**CITY OF SANTA ROSA**

**COMMENTS ON THE CONCLUSION THAT RIVER DISCHARGE IS  
LESS ENVIRONMENTALLY DESTRUCTIVE AMONG ALTERNATIVES**

## SOUTH COUNTY PROJECT

## COMMENTS ON THE EIR AS VIEWED BY RATEPAYERS

*9 of the 50 reservoir sites mentioned in the  
Hortley King Report.*

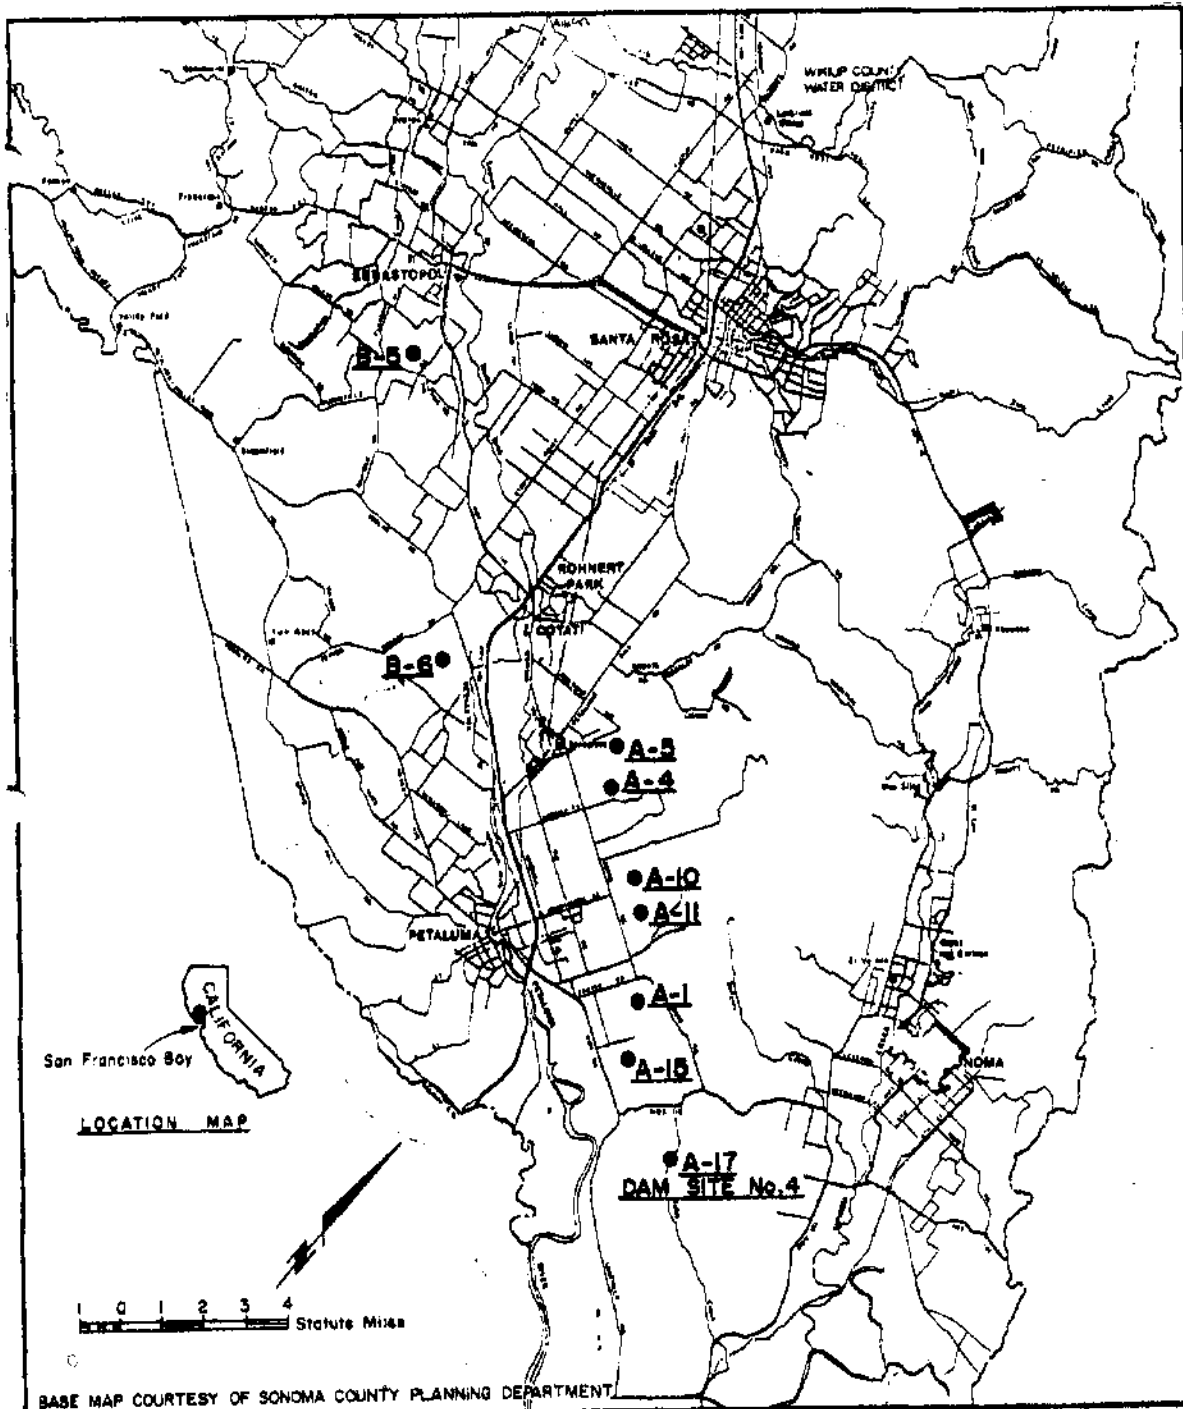
EIR fails to discuss:	012
1. Obtaining smaller sites	
2. Transmission line in center of potential irrigation acreage	013
3. Transmission line straight shot to Tolay	014
4. South County project makes available diked baylands which provide ability to expand the system in years to come	015
5. Financial advantages of a phased system.	016
